RE: **108-ZN-1984#2**  
Desert Cove Internalized Self Storage  
**3364E (Key Code)**

The Planning & Development Services Division has completed the review of the above referenced development application submitted on 7/25/2022. The following **2<sup>nd</sup> Review Comments** represent the review performed by our team and is intended to provide you with guidance for compliance with city codes, policies, and guidelines related to this application.

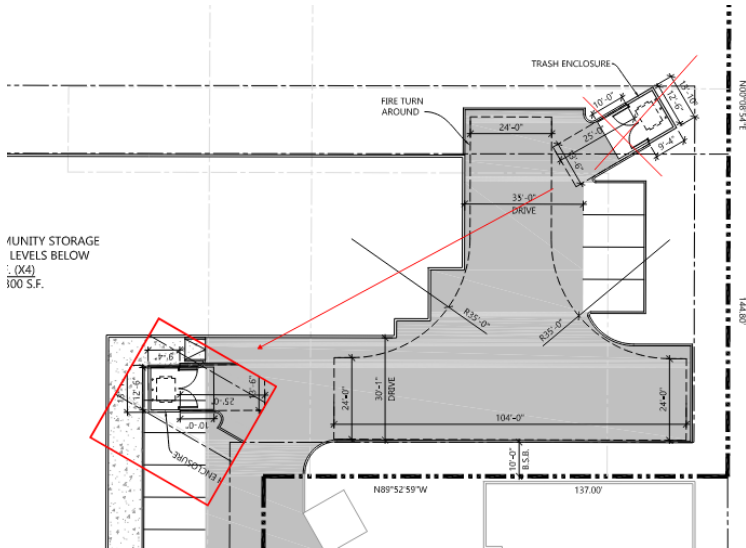
- 2. Please provide a revised Drainage Report and Grading and Drainage Plan with the resubmittal, addressing the following General Underground Storage Requirements:

- a. Level of detail required for the underground storage system design is 75% in the preliminary drainage report.
  - b. Drainage easement is required over underground storage system.

- c. Service life of 75 years MAG standard detail 2554
  - d. Underground retention system must drain by gravity
  - e. At a minimum 2 access points must be provided

- f. A signed and notarized ownership responsibility statement
  - g. Add the required warning signage, at minimum 2 signs
  - h. Plan: Add more spot elevations, particularly near the northern and eastern parcel limits. The adjacent parcel to the west drains part of the lot and building to the north in a depressed area which connects to this parcel.

- i. Plan: Review DSPM for minimum pipe size
  - j. Plan: Provide elevations for the underground system, the plan needs to include more details to verify the system will work.

- k. Plan: How will you address first flush at the site since everything drains to the underground system with no treatment.
  - l. Report: The area used in the computation is about an acre while the City GIS data and the County Assessor's website shows the area to be 1.35 acres or 60,000 sf. Review the retention volume calculations and verify the extents of improvements.

- m. Report: The report discusses an O&M manual provided with the submittal but could not locate it for review.
